ENGINE - AIR - INCORPORATE A REVISED SOLENOID SUPPORT BRACKET TO PROVIDE IMPROVED CLEARANCES BETWEEN BRACKET AND FAN CASE ASSEMBLY - CATEGORY CODE 6 - MOD.ENG-75-0036

V2500-ENG-75-0036

Location of bracket  
Fig.1

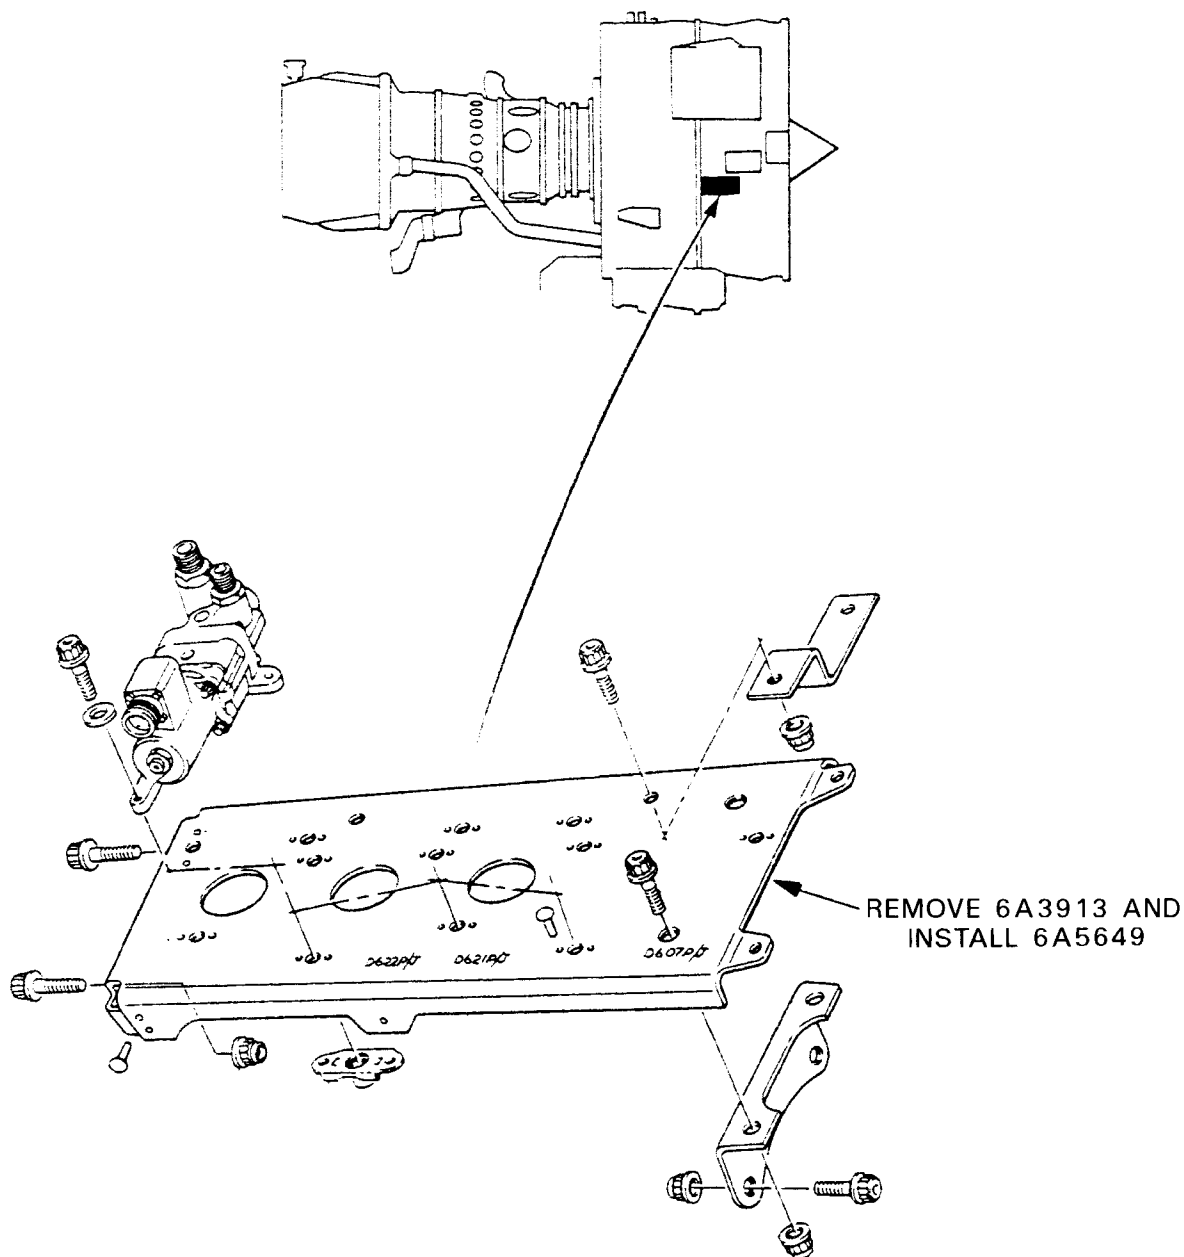
It was also highlighted that the clearance between the clips which are supported from the air bleed valve solenoid mounting bracket and the fan case was inadequate.

The increased diameter of the fan case on the V2500-A5 engine compared to that on the V2500-A1 engine has resulted in the clearance between the clips and fan case being reduced.

View on solenoid mounting bracket Before and after alteration  
Fig.2

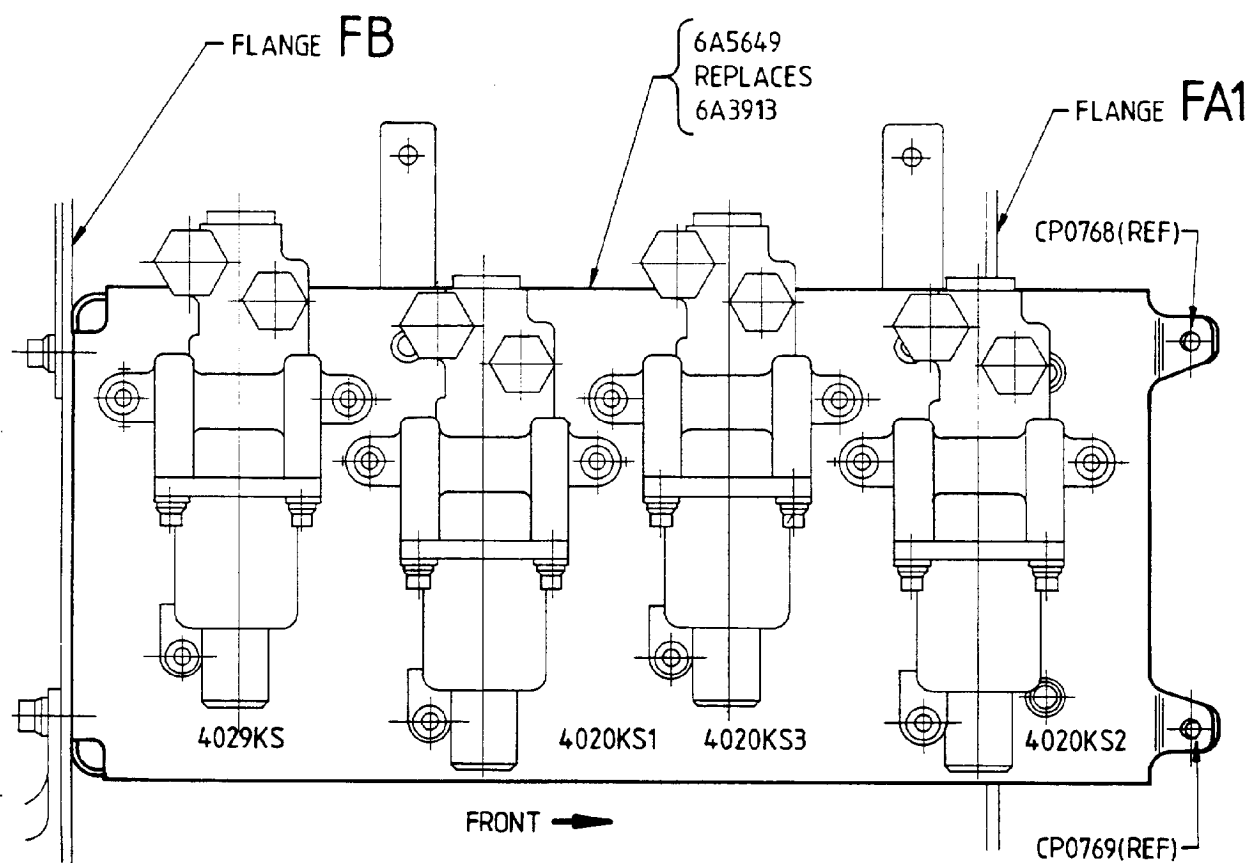
This Service Bulletin introduces a modified bleed valve solenoid mounting bracket with functional identification numbers etched adjacent to the 4 solenoids. The clipping lugs (for CP0768 and CP0769) are set at an angle of 25 degrees minimum instead of 20 degrees minimum.

Existing brackets can be reworked by cancelling the 'D' markings and etching on the new identification numbers, and by manipulating the lugs to achieve the revised angular position.

Procedure	Supplementary Information
(a) Find the clip points CP0768 and CP0769	See Fig. 2
(b) Adjust the lugs to the revised angular position of 25 degrees minimum	See Fig. 2 Use basic workshop tools
(c) Cancel the existing functional identification numbers and identify with the new functional identification numbers	See Fig. 2 Use vibro-engraving equipment. Refer to SPM TASK 70-09-00-400-501
(d) Cancel the existing part number and re-identify with the new part number	Use vibro-engraving equipment. Refer to SPM TASK 70-09-00-400-501 Existing          Re-number 6A3913          6A5649
